Re: Canon Dolomite Quarry, File # 1977-376
Response to Preliminary Adequacy Review for TR #02

**CANON DOLOMITE QUARRY
M1977-376**

TECHNICAL REVISION #2

CANYON DOLOMITE QUARRY
M-1977-376
**MINING PLAN
EXHIBIT C-2**

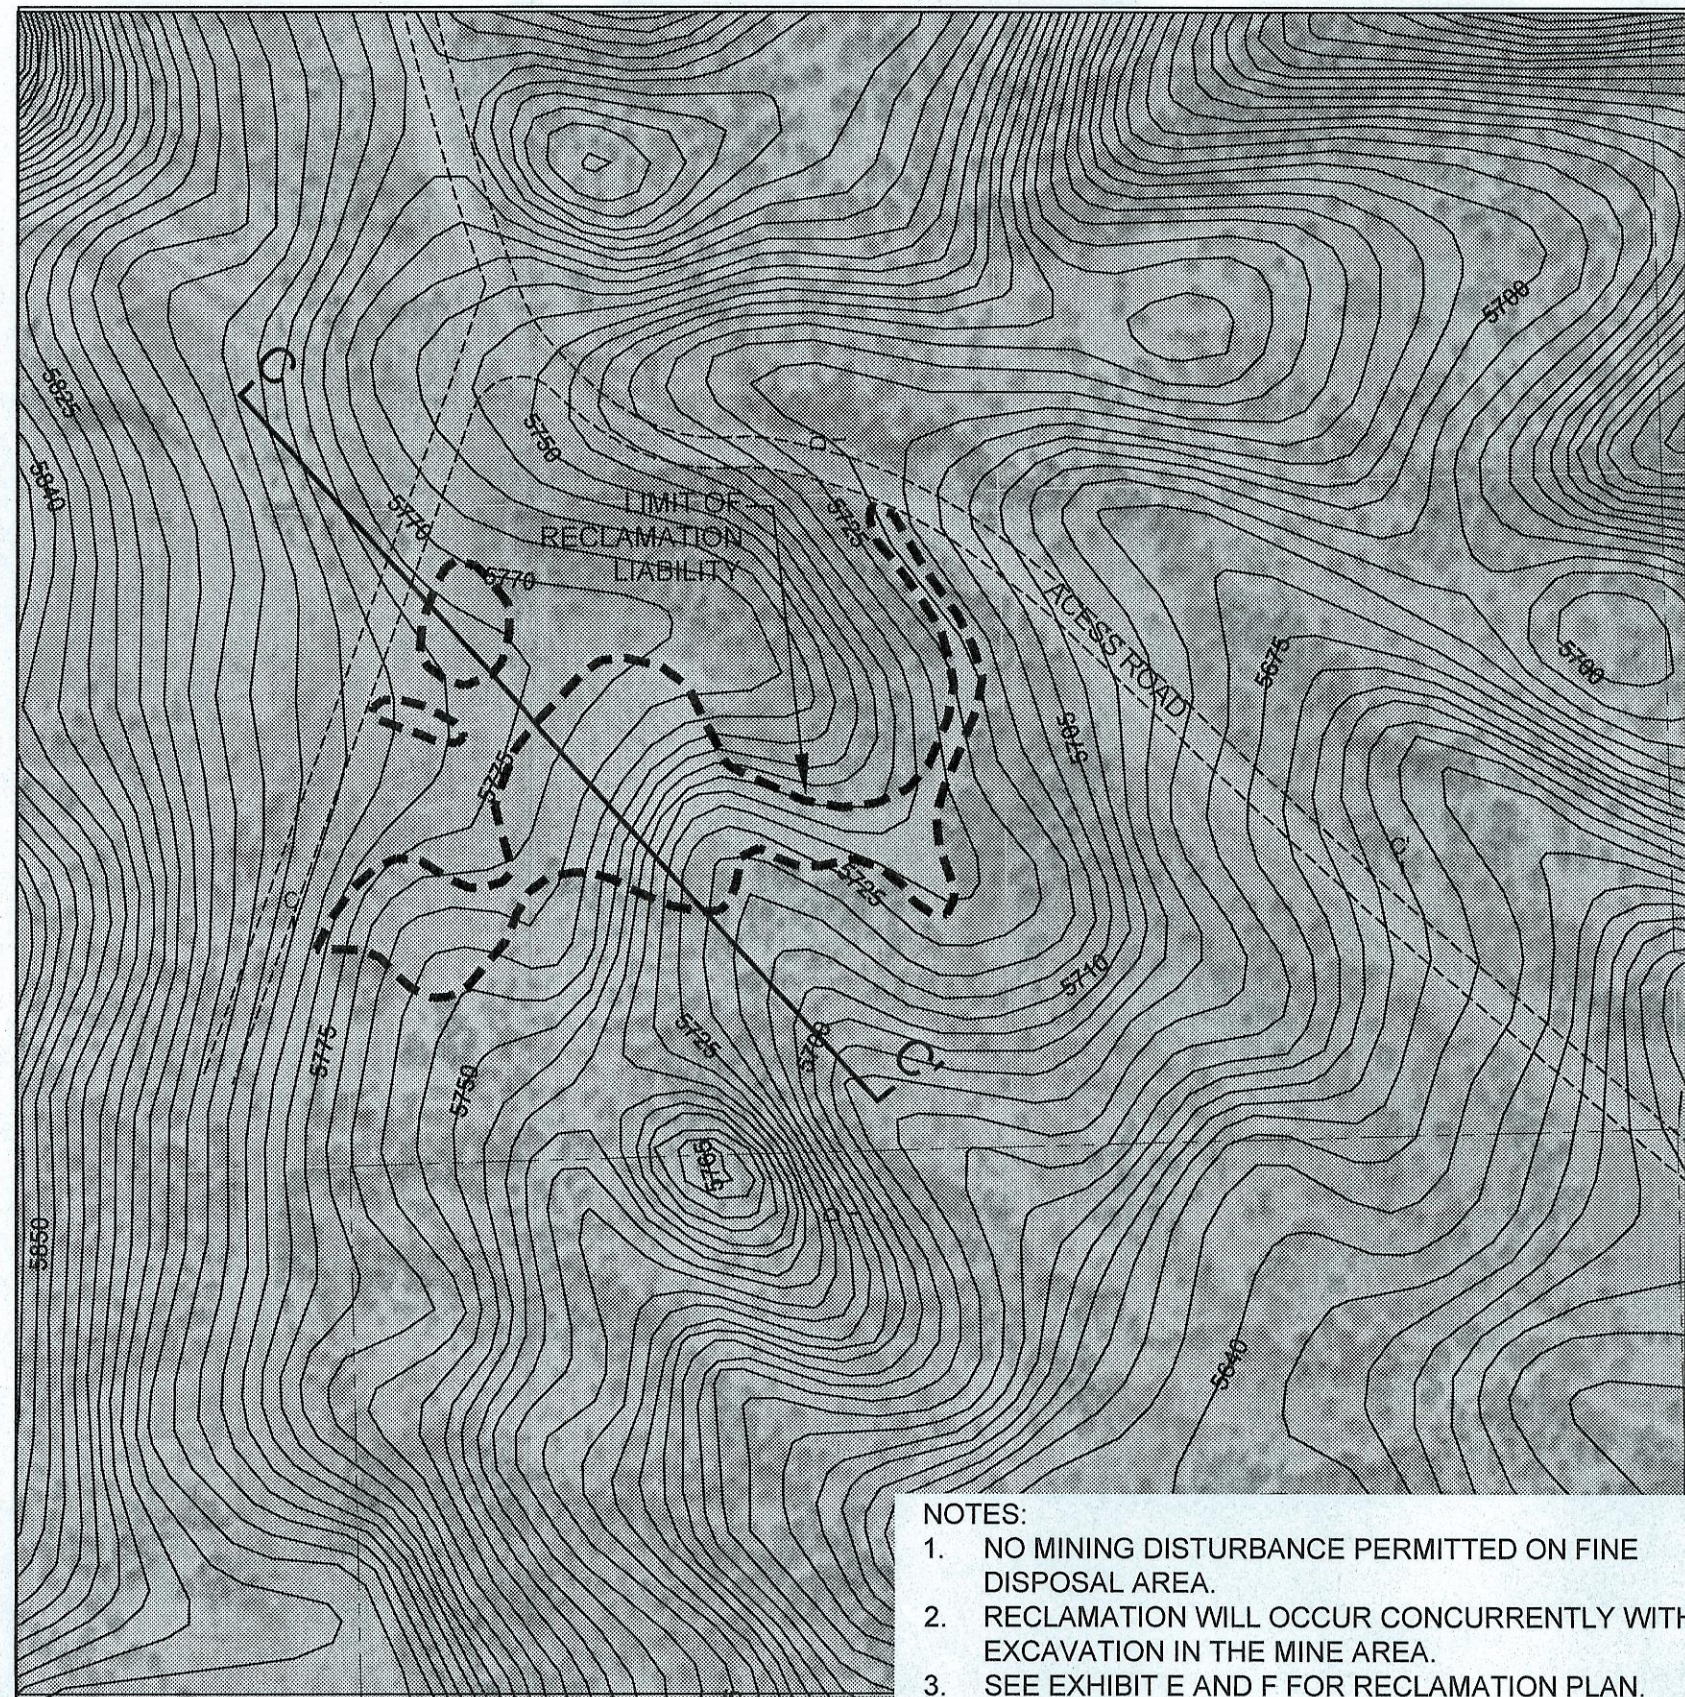
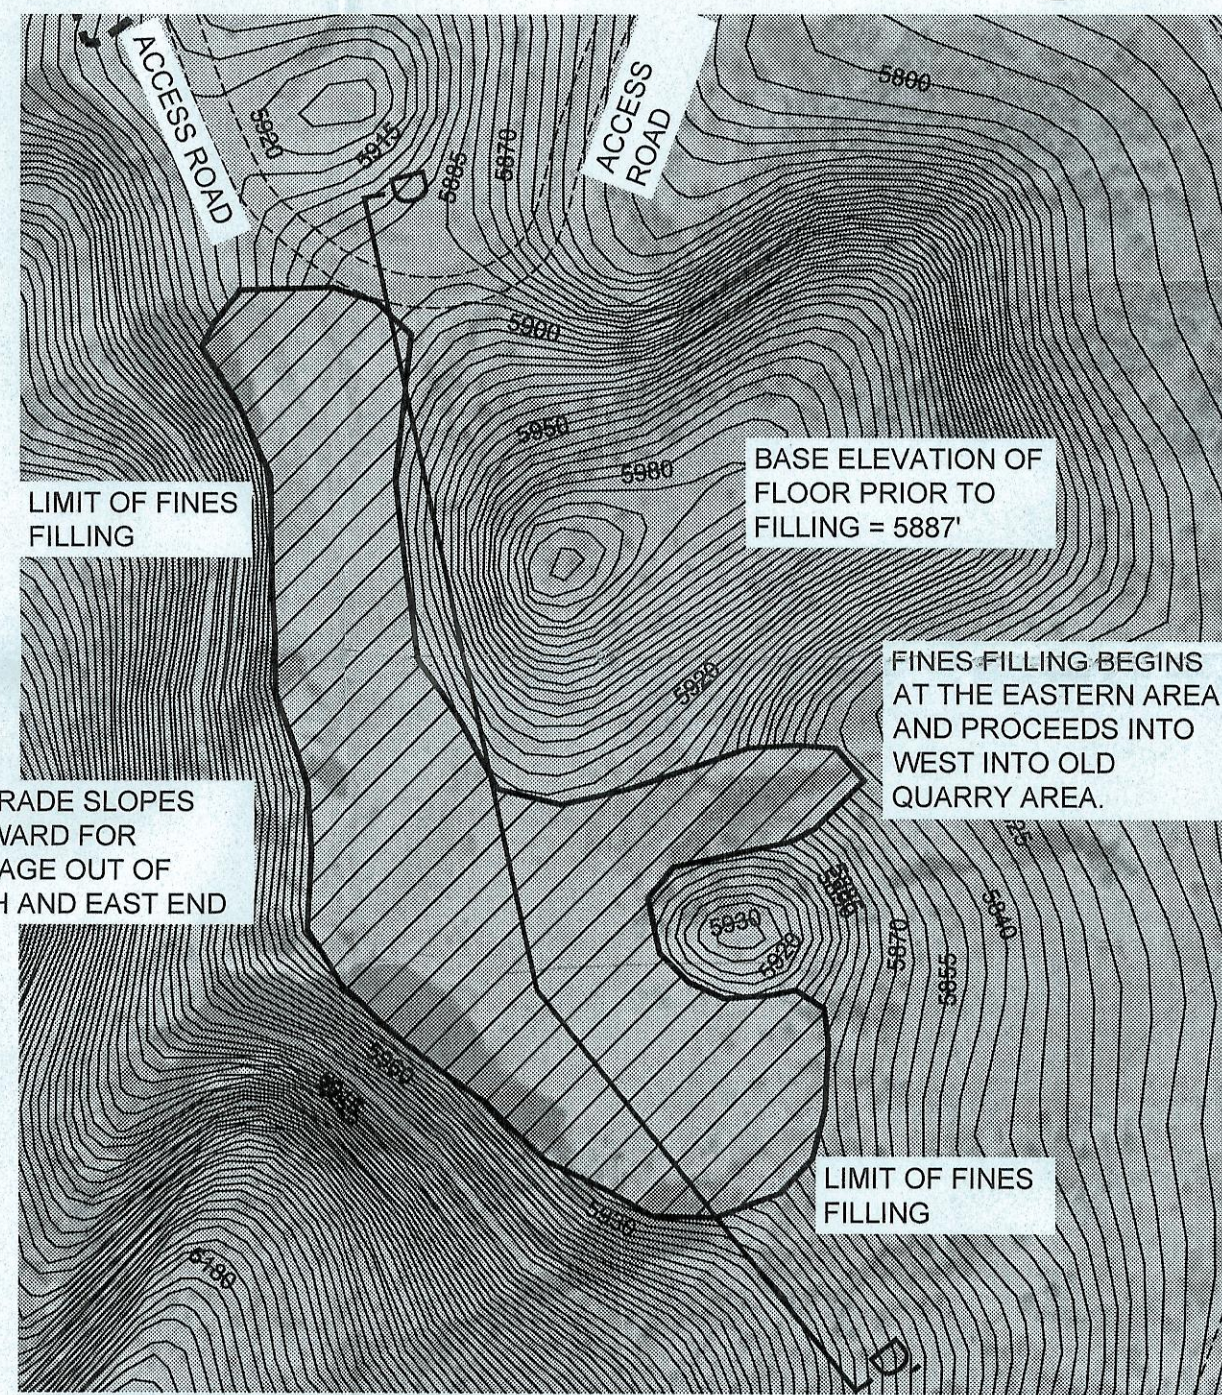
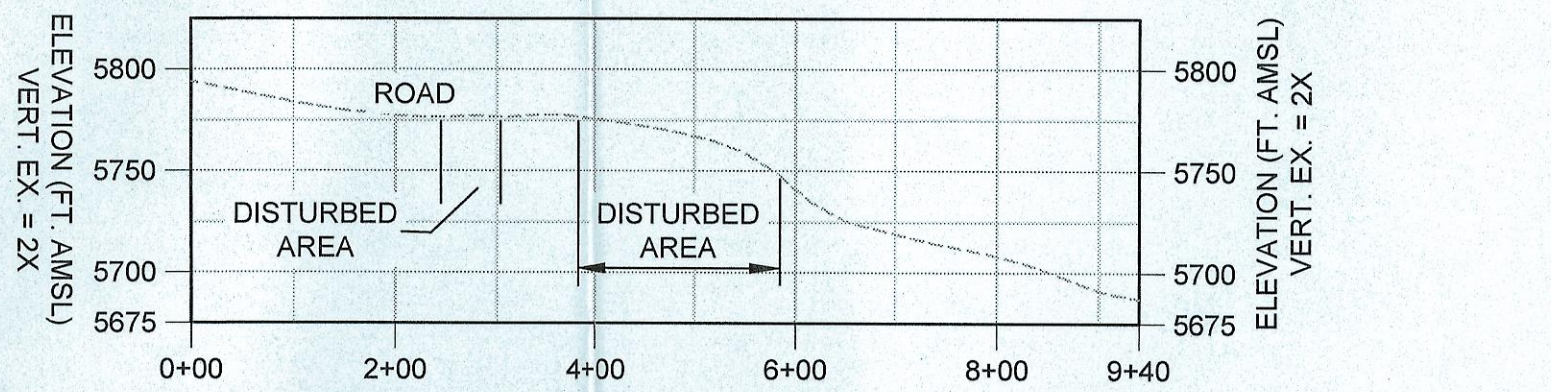
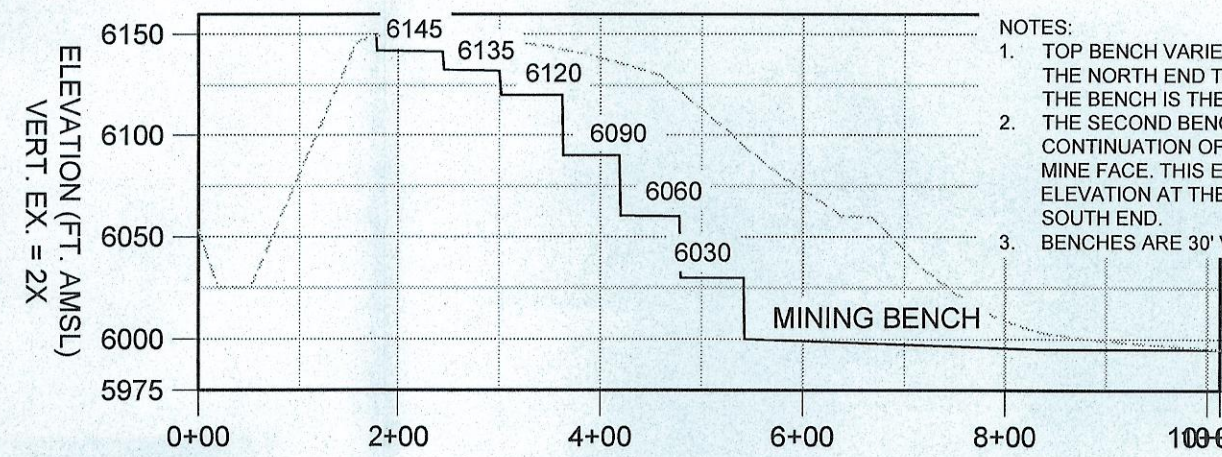
2. Exhibit C-2, Mining Plan
 - a. See explanation in 1.a.
 - b. During most of the operation (down through bench 6060'), the majority of the excess fines produced by the processing plant will be moved to the Old Quarry Fines Disposal Area. The remainder will be used to backfill the vertical benches. Toward the end of the operation (benches 6030' and 6000'), an ample amount of the excess fines will be temporarily stockpiled on these benches for the cover on the large open portion of the final bench

(6000'). We expect little fines will be hauled to the Old Quarry area in the last stages of mining. These retained fines will be pushed down from bench 6030' or pushed around bench 6000'. The open area of bench 6000' will absorb the excess fines and the cover depth may vary from 6" to 12". Volume calculations will periodically be done to insure adequate fines are temporary stored and fines are not hauled back from the Old Quarry area to get adequate cover on bench 6000'.
